SERVICE BULLETIN

SS-MAR0234

model number 10B	bulletin number M-10B-2
for serial numbers ALL	
subject WARM UP TRANSIENTS	
engineering approval <i>[Signature]</i>	date 6/17/76

At Stereo Switch RPL2, install two 470K ohm 1/4 W resistors (part number 434-6472) as shown below:

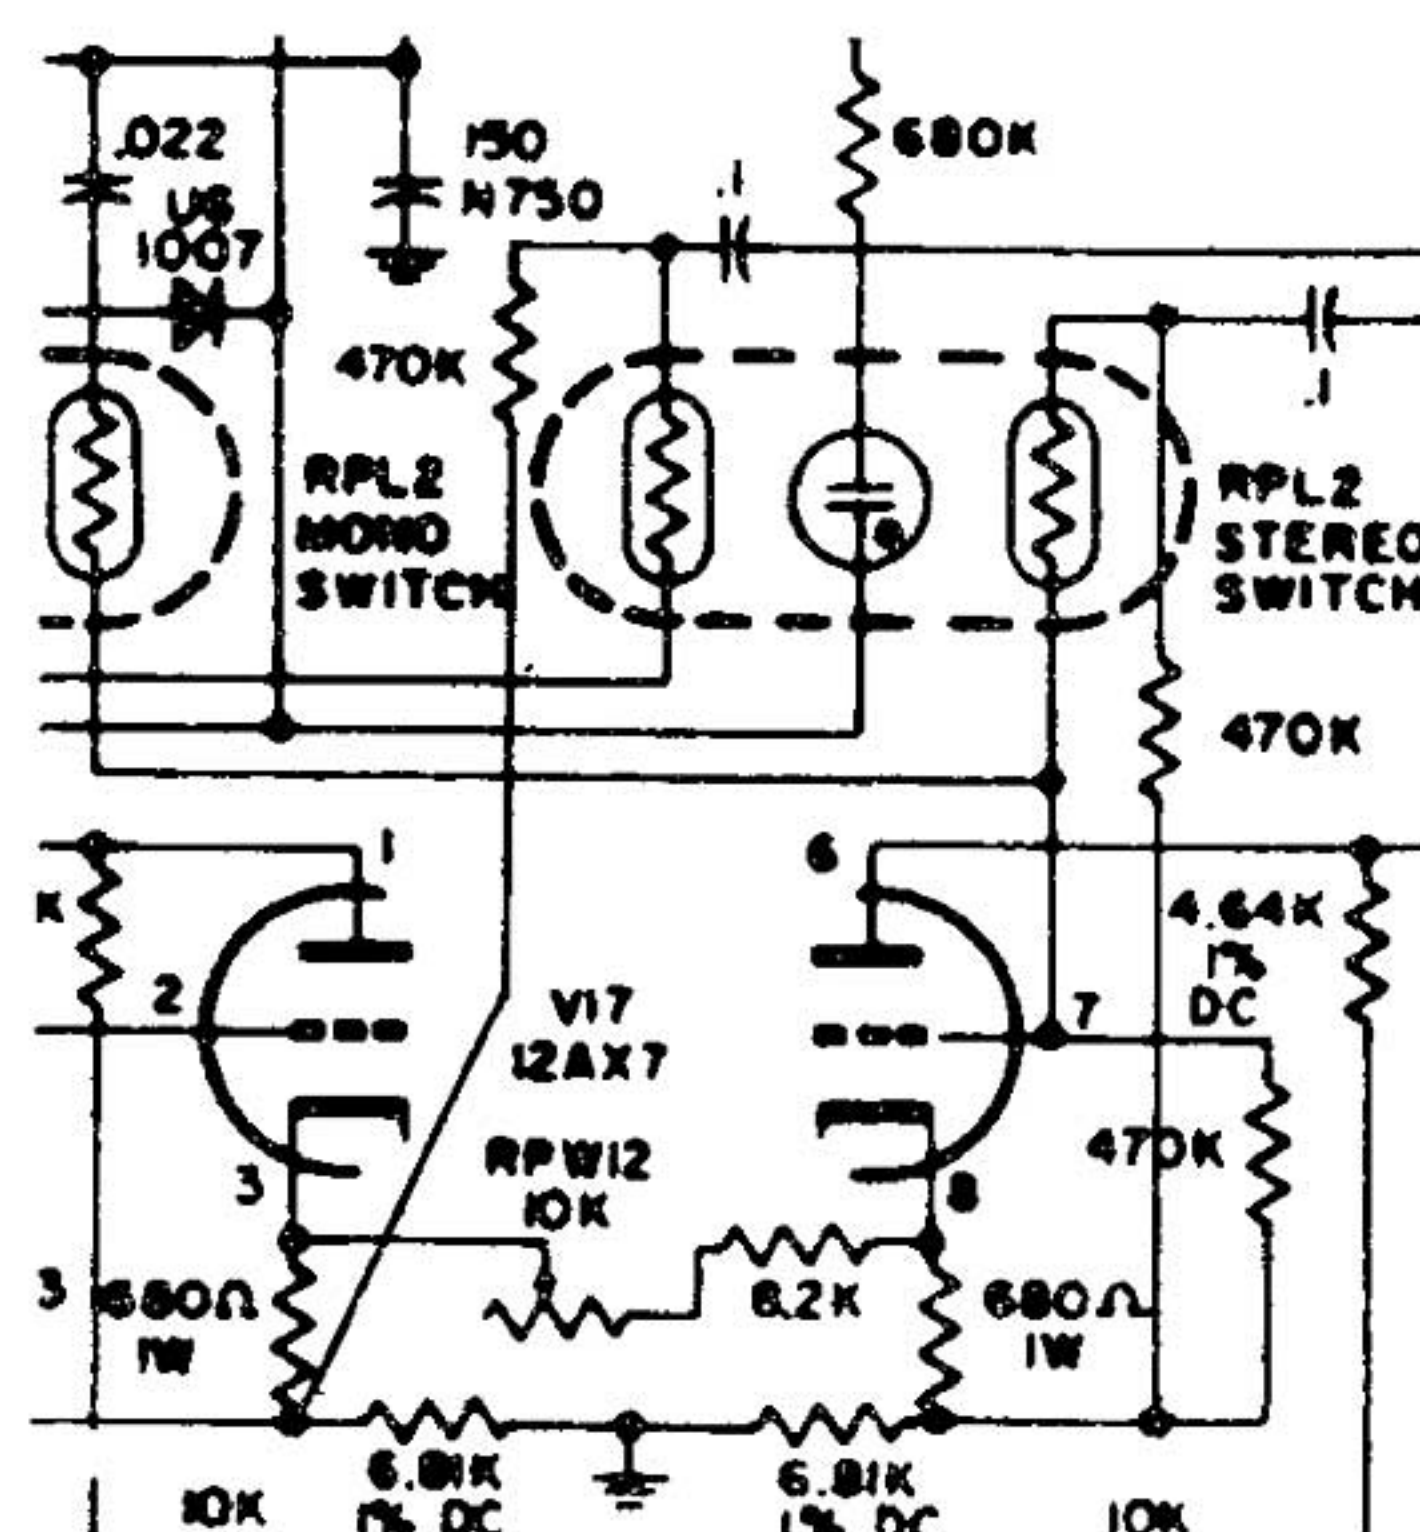
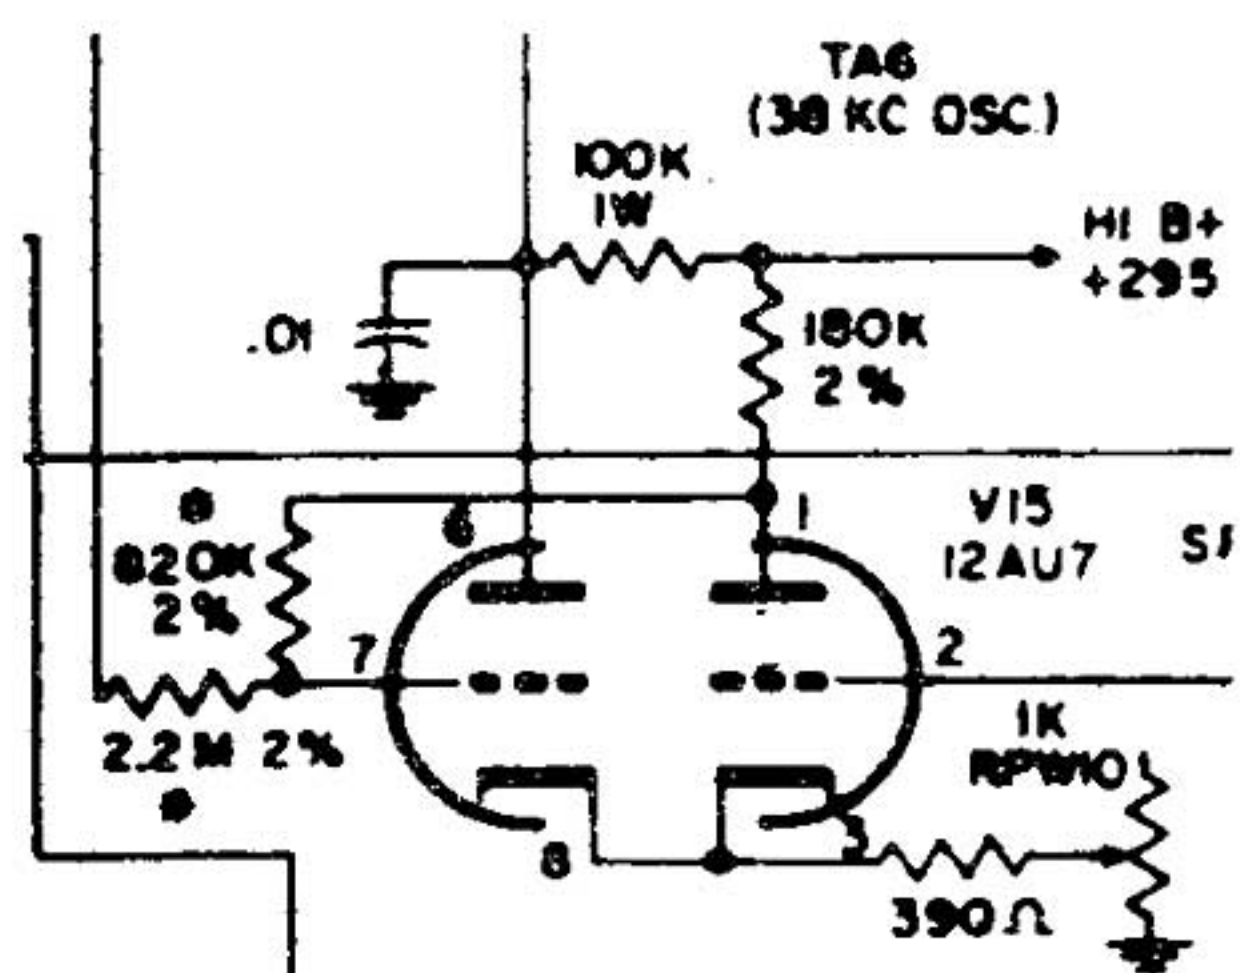
If you receive customer complaints regarding strong pop transients from the Marantz Model 10B during warm-up, the following modification is recommended.

ORIGINAL

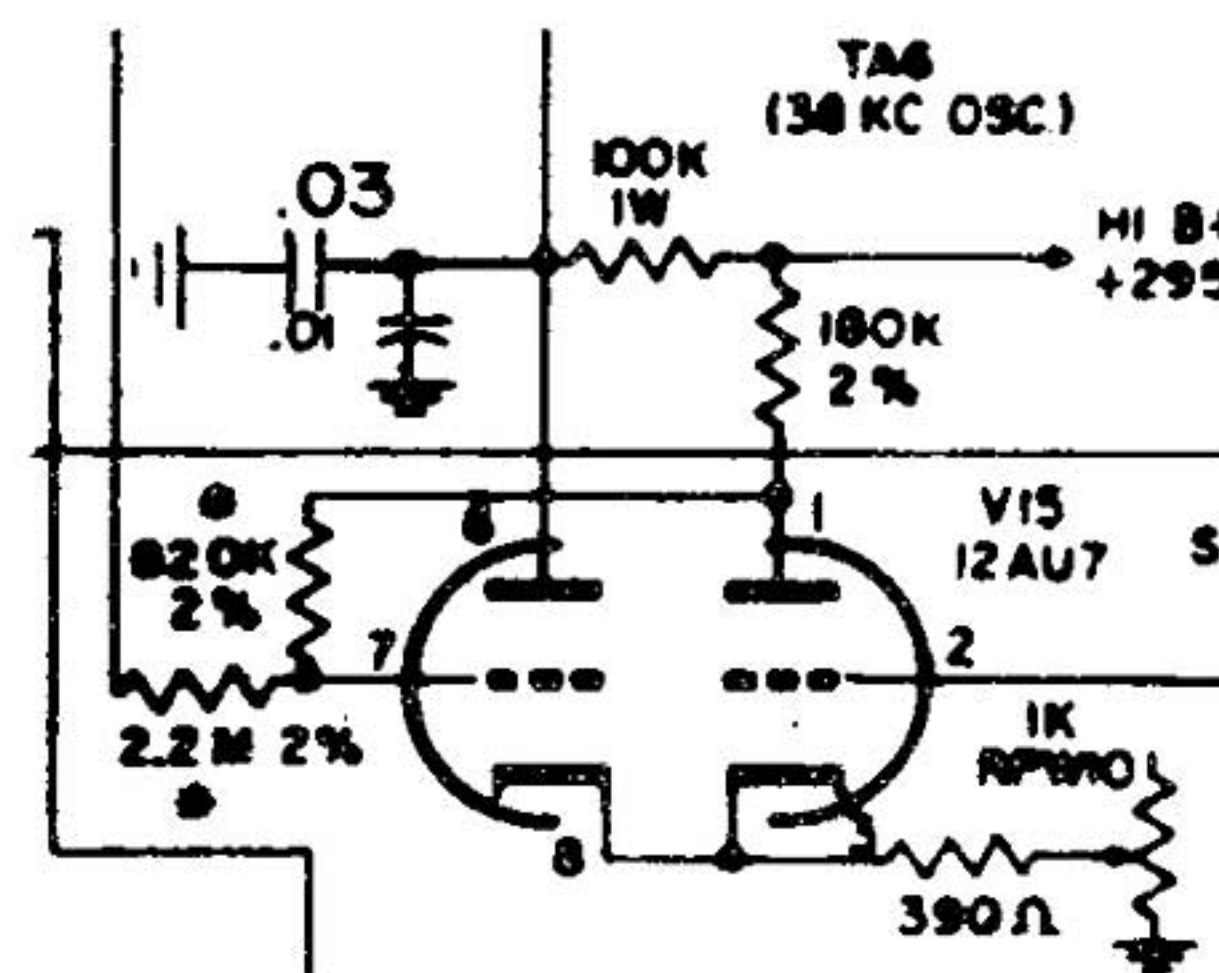
If a click noise occurs when the stereo indicator lamp is activated, it is recommended a .03 uF 450 V capacitor be installed at V15 as shown below:
